**To:** Planning Committee **Date:** June 27, 2006  
**From:** Jean Lamontagne **File:** RZ 05-317472  
Director of Development  
**Re:** **Application by Rize Alliance (Richmond I) Properties Ltd. for Rezoning at 8080 and 8084 Granville Avenue and 7080 No. 3 Road from Automobile-Oriented Commercial District (C6) and Downtown Commercial District (C7) to Comprehensive Development District (CD/176)**

## Staff Report

## Staff Technical Comments

DRAWING  
**PLAN - LEVEL 4**

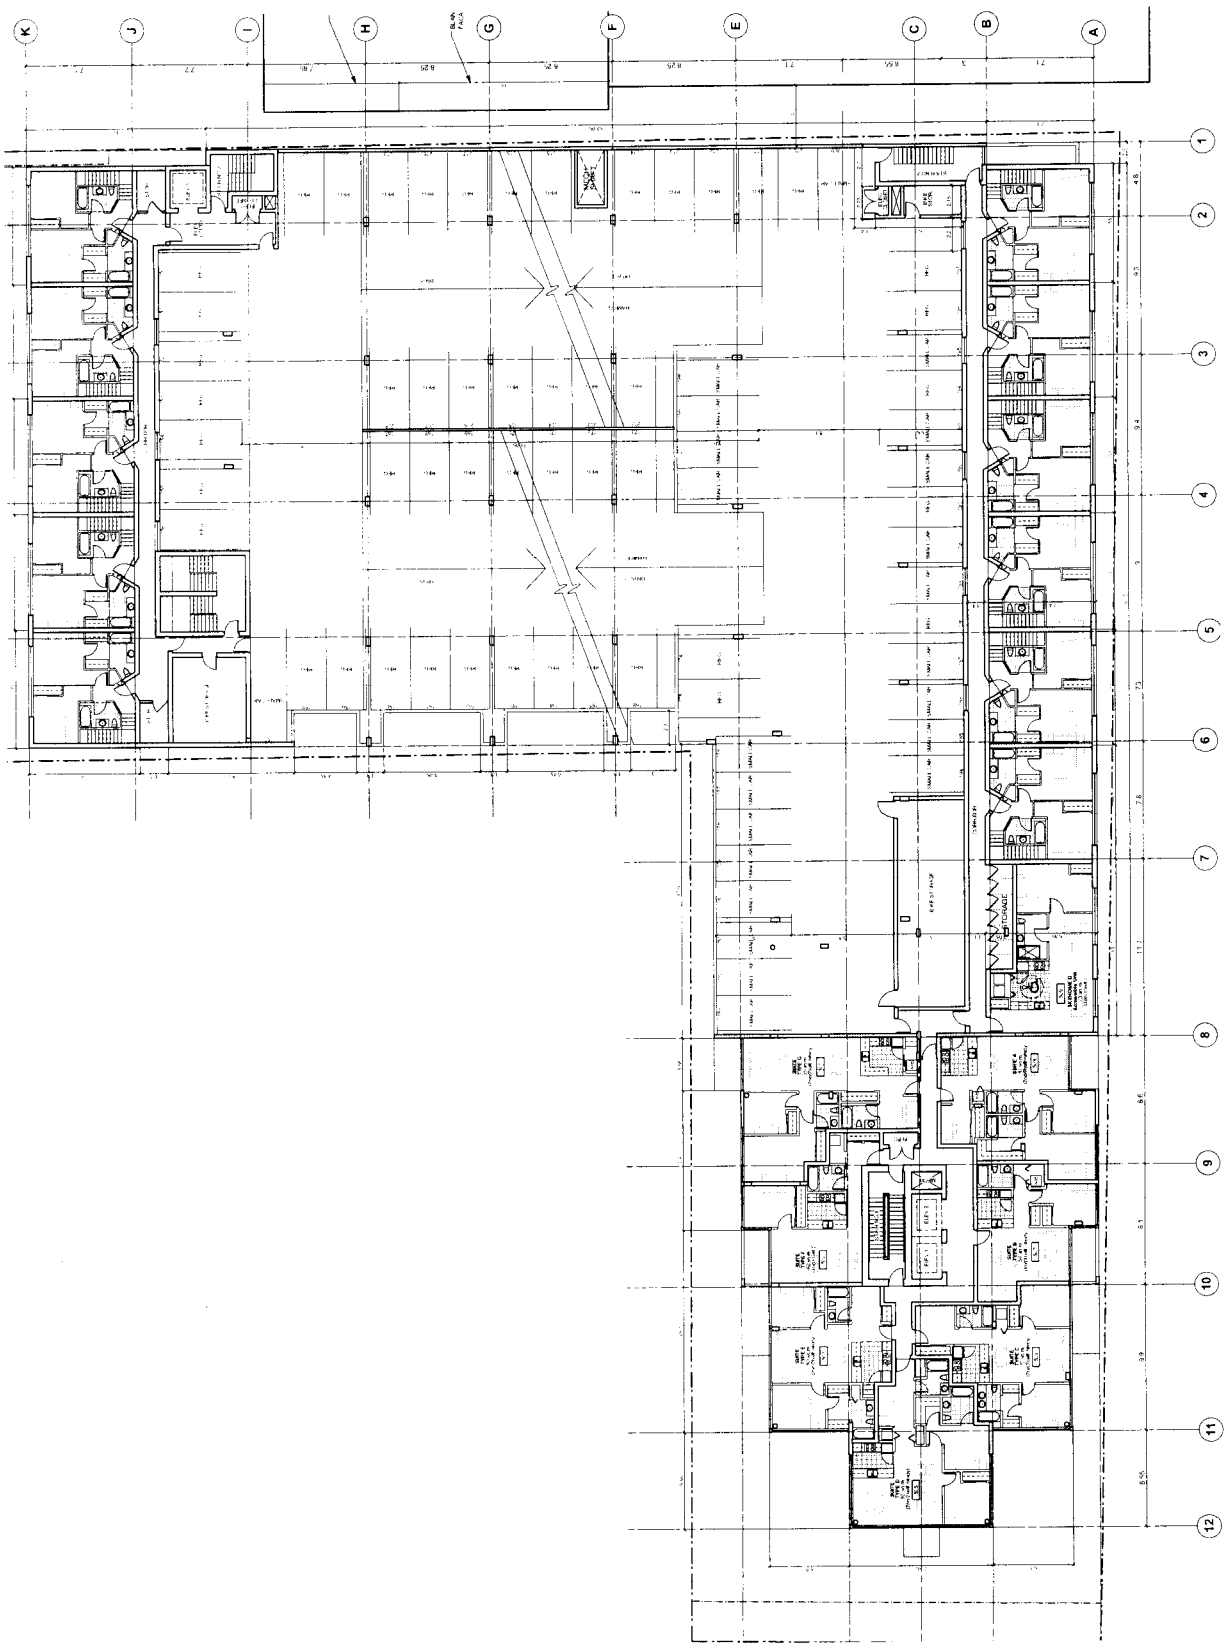
- Provide additional corridor access to Skyhomes. The separation between the stairwell access and units is too long (page A2.4 Level 4)
- Consider introduction of a trellis/lattice over the teahouse/garden area to address overlook and privacy issues.
